VSP 90
April 17, 1989

VENDOR SERVICE PUBLICATION

SUBJECT: Facet Aerospace Products, Co. Service Bulletin A1-88

SUBJECT: Possible Loose 62-226 Pins

FIG. 1

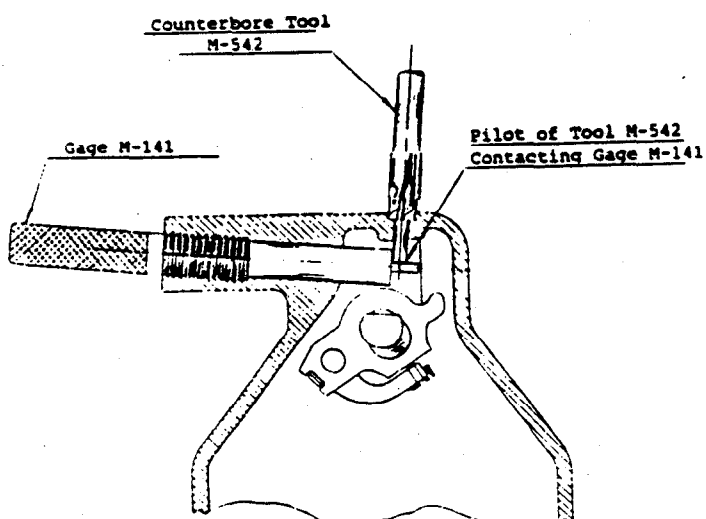
Lubricate the Gage M-141 and insert in the air metering channel completely (Fig. 1) insuring that the small end of the gage is visible under the hole created by removal of the 62-226 Air Metering Stop Pin.

With the counterbore Tool M-542 in a hand chuck or a slow variable speed drill motor carefully insert the pilot of the M-542 Tool in the air metering stop pin hole (Fig. 1) and rotate clockwise applying very light pressure until the pilot of the counterbore Tool M-542 contacts the Gage M-141. Stop, this controls the depth of the counterbore and the position of the 62-F1 Pin.

DO NOT ATTEMPT TO DO THE ABOVE IN A DRILL PRESS. The air metering stop pin hole will be damaged. It is drilled at an angle to the flange.

FIG. 2

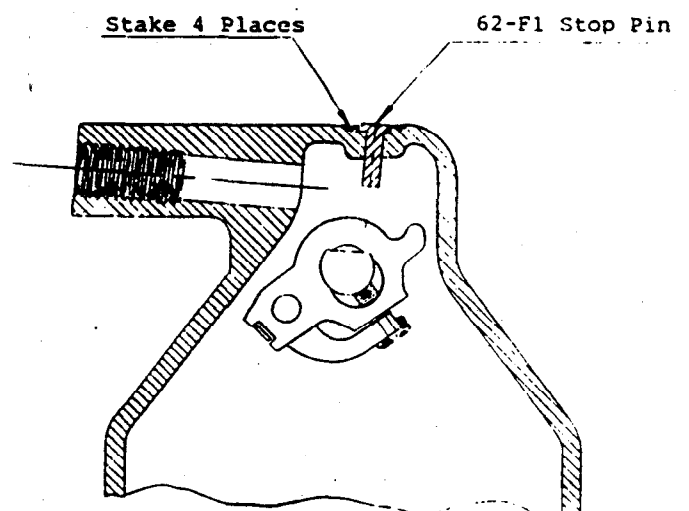
Start the 62-F1 Air Metering Stop Pin in the stop pin hole and apply a coating of loctite grade 272 or equivalent to the 62-F1 Pin. Continue pressing in until the 62-F1 Pin is seated in the newly formed counterbore (Fig. 2). Use a center punch to stake the casting 4 places around the head of the 62-F1 Pin.
